BHLARAI DH WIND FARM EXTENSION EIA GATECHECK REPORT

Document Information

Project Name:	Bhlaraidh Wind Farm Extension
Document Title:	EIA Gatecheck Report
Client Name:	SSE Generation Limited
Client Address:	1 Waterloo Street, Glasgow, G2 6AY
Document Status:	Final for Issue
Author:	[REDACTED]
[REDACTED]	[REDACTED]
Approved:	[REDACTED]
Date:	2020-11-02
Version:	3.0
Project/Proposal Number:	EDI_1571
ITPEnergised Office:	60 Elliot Street, Glasgow, UK, G3 8DZ

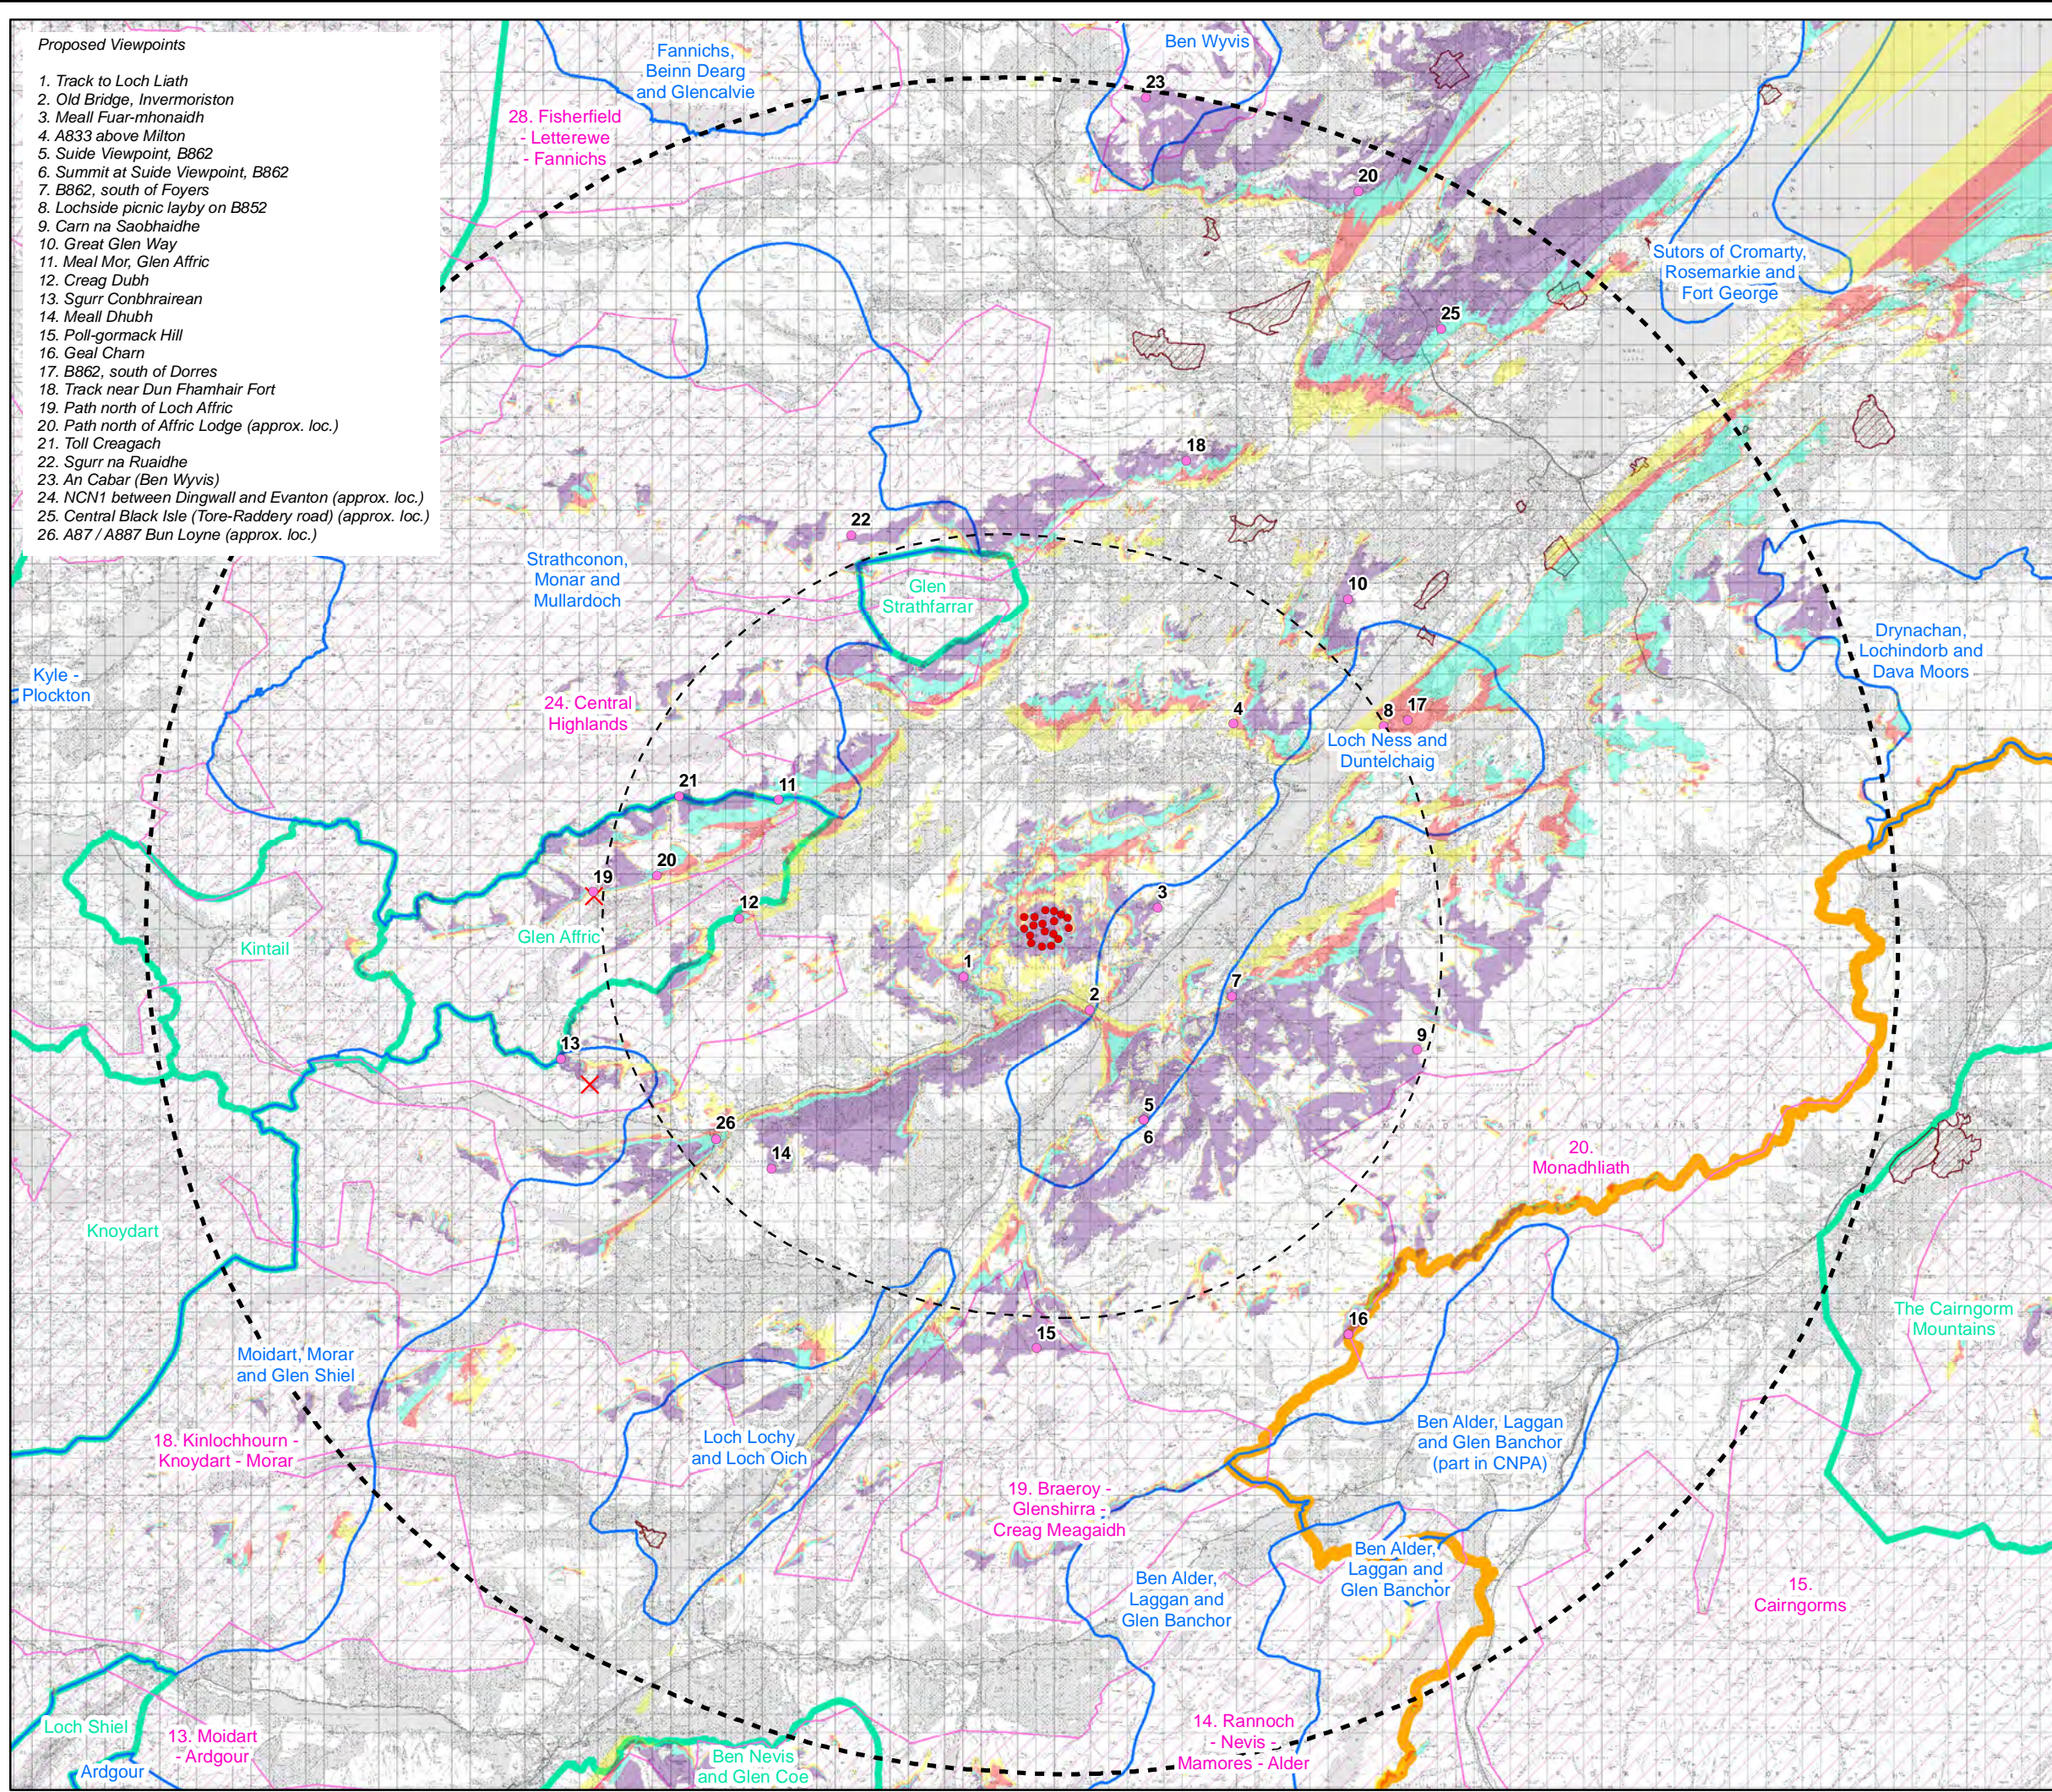
Since October 2019, some small amendments and clarifications have been made to the Proposed Development (reference Layout SSE DL03), and consequently to the VPs, as detailed in the attached document. A list of proposed viewpoints is appended to this letter (119009-N-VP2-1.0.0), with a viewpoint plan (119009-D-VPC2-1.0.0).

- All other VPS in the attached document remain as they were in our October 2019 consultation, but with some updated VP numbering. We have not identified any other areas of 'new' theoretical visibility occupied by the current Proposed Development (Layout SSE DL03) that would require other VPs.
